**Work Order ID 112868**

Item Name: Fwd Crosstube

DRAWING NO. D407-667-145	TITLE CROSSTUBE ASS'Y (407 HIGH FWD)	REV. C	DART AEROSPACE LTD ENGINEERING ORDER		D.E.O. NO. D407-667-145-C-1	SHEET NO. SHEET 1 OF 1	SCALE NTS
DRAWN <i>q</i>	CHECKED <i>ASS</i>	MFG. APPR. <i>IS</i>	APPROVED <i>WD</i>		DE APPR. <i>##</i>		
DATE 11.07.15	DATE 11.07.22	DATE 11.07.22	DATE 11/07/22		DATE 11.07.21

DRAWING NO. D407-667-145	TITLE CROSSTUBE ASS'Y (407 HIGH FWD)	REV. C	DART AEROSPACE LTD ENGINEERING ORDER		D.E.O. NO. D407-667-145-C-2	SHEET NO. SHEET 1 OF 1	SCALE NTS
DRAWN AJ5	CHECKED	MFG. APPR.	APPROVED	DE APPR.			
DATE 12.08.02	DATE 12.08.02	DATE 12.08.02	DATE 12.08.02	DATE 12.08.02	DATE 12.08.02

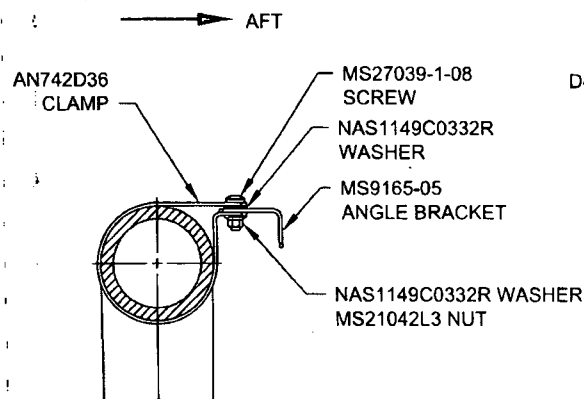
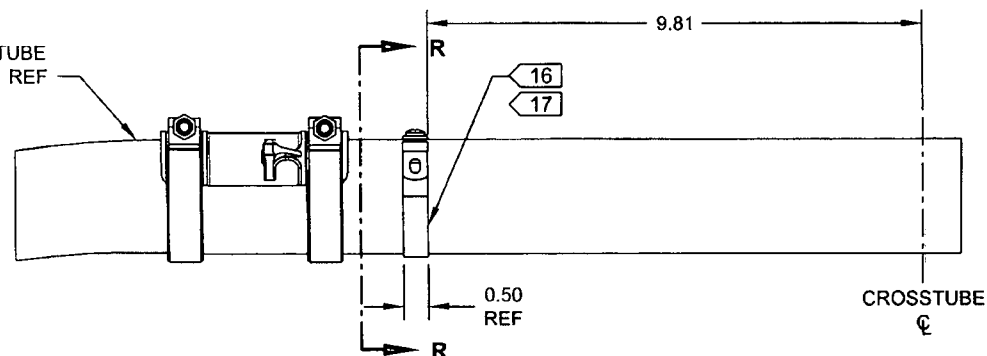
ADD ELECTRICAL GROUNDING STRAP

ITEM	QTY -145	PART NUMBER	DESCRIPTION
1	X	D407-667-145	CROSSTUBE ASSEMBLY (407 HIGH FWD)
⚡			
10	2	AN742D36	CLAMP
11	2	MS9165-05	ANGLE BRACKET
12	2	MS21042L3	NUT (OR MS21042-3)
13	2	MS27039-1-08	SCREW
14	4	NAS1149C0332R	WASHER (OR AN960C10L)

**DETAIL P**  
BONDING STRAP INSTALLATION 2 PL
